Re: Site & soil evaluations at 11405 Skyline Road in Forestville, CA 95436
APN: 081-010-008 Permit #: WSR21-0528

Pre-Perc Field Notes

Hydrometer Test Data Form

Pre-perc scheduling for 11405 Skyline Road in Forestville

Soil Texture Triangle Chart:

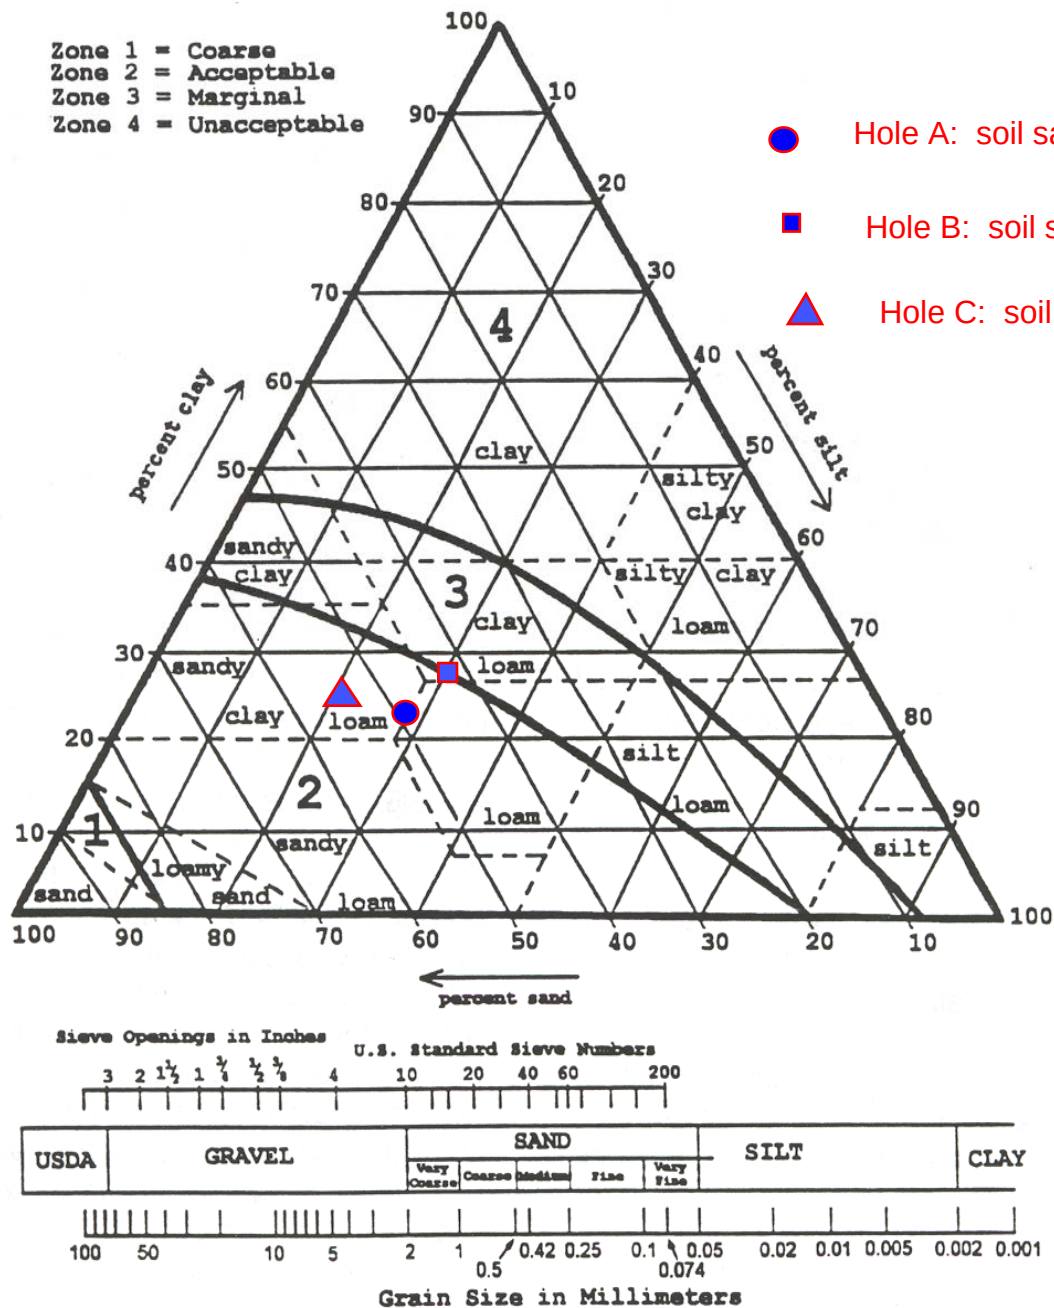
1. Have you adjusted the points for coarse fragments? This may squarely place the point into either zone 2 or zone 3 and provide a definite answer in terms of policy.
2. What are your thoughts on the matter? Can you provide a good reason to not conduct percolation testing? This is a matter of time, cost, and ensuring an adequate functioning system.

Hi Ben. The pre-perc soil lab test shows one of the soil samples to be within the curve line between zone 2 and zone 3 in the soil triangle texture chart. How do we interpret this? Zone 2 (no percolation test) or zone 3 (need percolation test)? Specifically soil sample in soil profile hole B from 20-35" depth.

I appreciate that you made this my call. Based on the soil structure and the fact that it had many fine roots makes me think that a percola on test should not be required if I were to review the plans because I believe that it would indicate that both evapotranspira on would occur through the roots and that it would also percolate down the con nuous soil horizon.

I cannot guarantee that if someone else reviews the plans in the future that they would agree with my assessment, there are occasional debates regarding this point and it goes against policy to make those comments on the pre perc itself.

That said, you have my opinion for your records as the inspector onsite, you were also onsite so I think that should be a very strong argument in favor of not requiring a percola on test if the plans are reviewed by another inspector.

The rock content is too small to adjust.

The point that we want to think about is whether we think this soil is permeable. If it is, then we can use the soil chart to get the soil absorption rate. If it doesn't, then it will require a percolation test.

The soil layer in soil profile hole B between 19-39" showed friable clay loam soil with many fine roots. I think the soil is permeable and a soil absorption rate of . gal/sq/day can be used. I remembered we pour some water on a soil pad and it was absorption the water well.
